**WHEELING PLAN COMMISSION
THURSDAY, FEBRUARY 8, 2018 AT 6:30 P.M.**

RE: Docket No. PC 18-2
CMX
Building J of the Wheeling Town Center Development
Site Plan & Appearance Approval of Façade Modifications

RE: **Docket No. 2018-1A&B**
Eagle Gourmet Cafe
1201B W. Dundee Road
(2018-1A) Variation from Title 19, Zoning, Regarding
Required Parking
(2018-1B) Special Use-Site Plan Approval of a Sit-Down
Restaurant

RE: **Docket No. 2018-2**
Uptown 500
500 W. Dundee Road (formerly 501 W. Dundee Road)
Amendment to a Planned Unit Development for to Allow for
an Additional Story on a Mixed-Use Retail and
Residential Building

North Courtyard Elevation

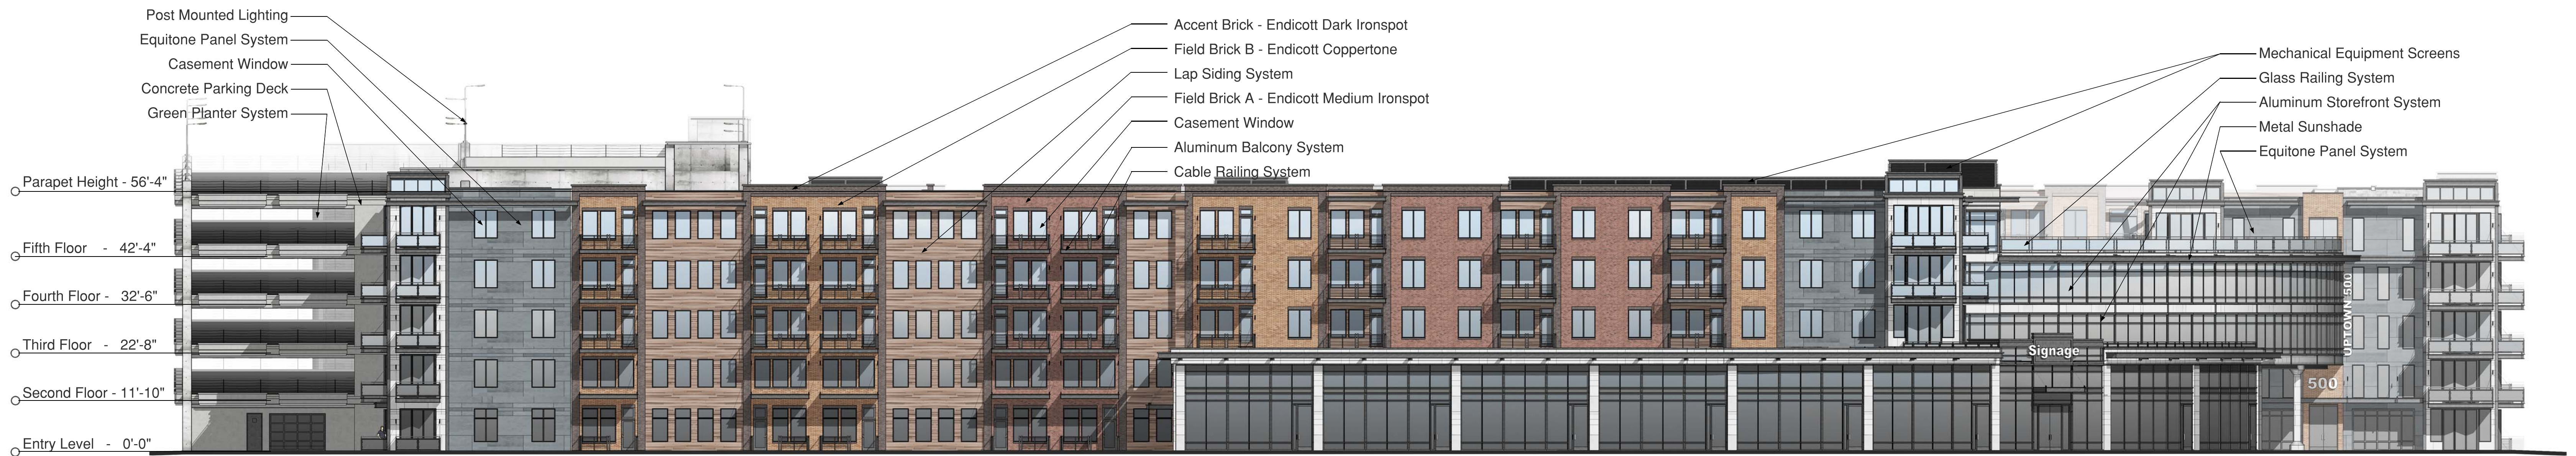
Staff has noted two additional appearance modifications from the approved plans at Final PUD: First, the courtyard (interior) elevations show that the amount of brick used for the wall materials has decreased significantly. It appears that some of the brick has been replaced with fiber cement panels. The Plan Commission may wish to have the petitioner clarify the courtyard elevation materials since the courtyard elevation plan is not labeled. Second, staff has noticed that the window type and design throughout the building elevations have changed since Final PUD. The previously approved window was a casement. Now, the plans show a single-hung window. The Plan Commission may wish to ask the petitioner to identify if there are any other appearance changes since Final PUD. The previously approved elevation plans have been provided by staff to assist the Plan Commission in its review.
